## Product Change Notice (PCN)

PCN Number: **PCN-0451399R-01**

Product(s) Affected: *PJ-063AH & PJ-063BH*

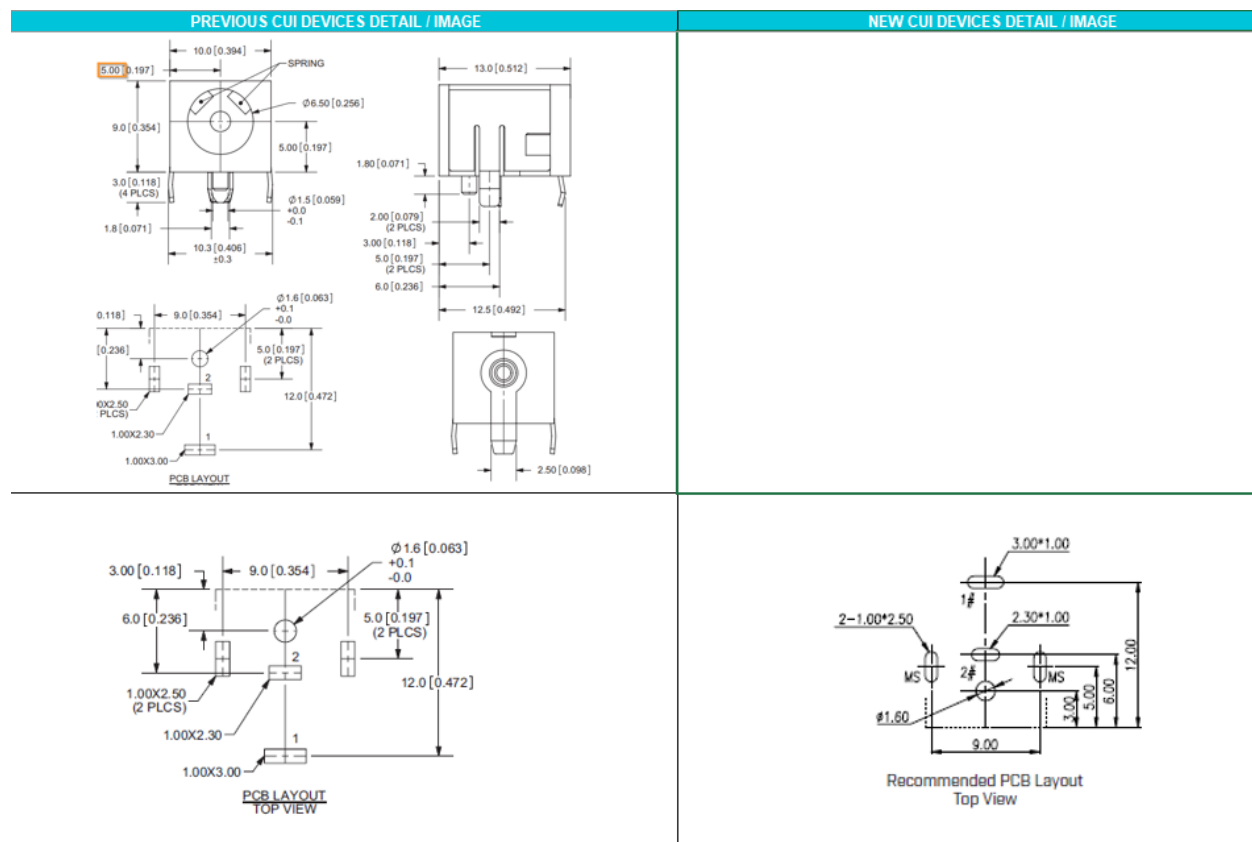
Description of Change: *Mold Change. Cosmetic differences on the mold. Stamping removed ("P" & "Made in China") All measured dimensions on the 2D drawing remain the same.*

PREVIOUS CUI DEVICES DETAIL / IMAGE			NEW CUI DEVICES DETAIL / IMAGE		
	MATERIAL	PLATING		DESCRIPTION	PLATING/COLOR
center pin	copper	nickel	center pin	copper	nickel
terminal 1	brass	silver	terminal 1	copper alloy t=0.40	silver
terminal 2	copper alloy	silver	terminal 2	copper alloy t=0.25	silver
spring	copper alloy	silver	spring terminal	copper alloy t=0.25	silver
shield	brass	nickel	shield	brass	silver
plastic	PBT		cover	PBT (UL94V-0)	black
			housing	PBT (UL94V-0)	black

MATING PLUG  
Jack Insertion Depth: 8.85 mm

MATING PLUG  
Jack Insertion Depth: 8.30 mm
